Permit ID: C1993017
Revision Type: Major Revision
Permitting Action: Deficiency
Subject: TR3; First Round Acceptability Deficiency

The Department of Environmental Quality (DEQ) has completed its acceptability review regarding Signal Peak Energy, LLC's (SPE) application for Major Revision TR3. The following deficiencies must be adequately addressed before DEQ can determine the application acceptable:

SECTION b-b'

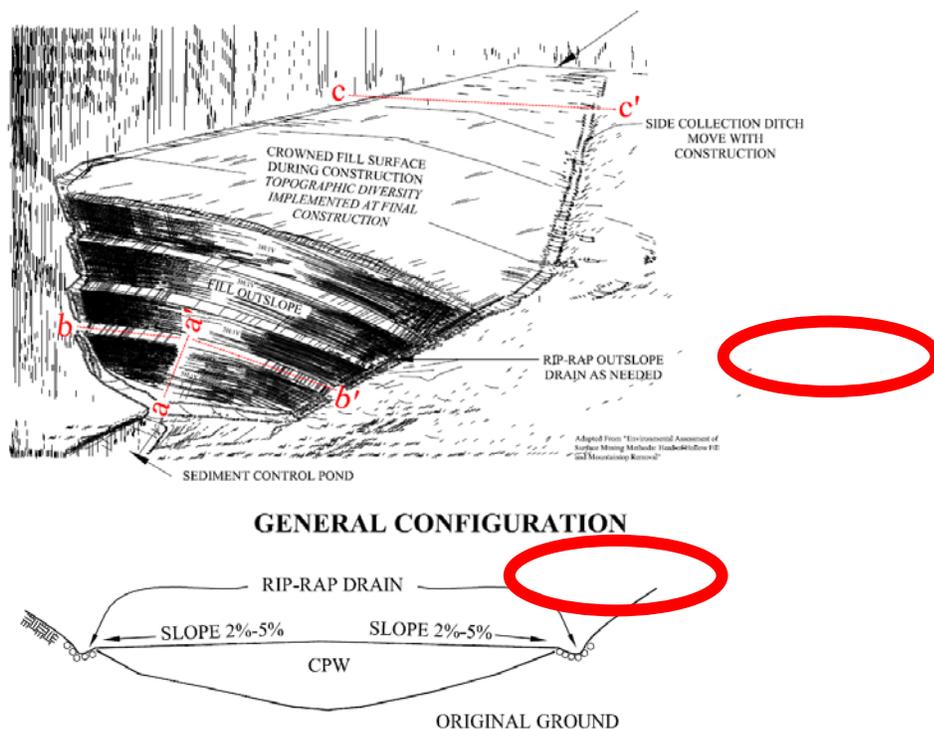
Sheet C2 of Sediment Pond E-TR2 Details must show a complete design of Pond E Spillway. Cross-section B only depicts the existing ground surface and it must also depict the spillway.
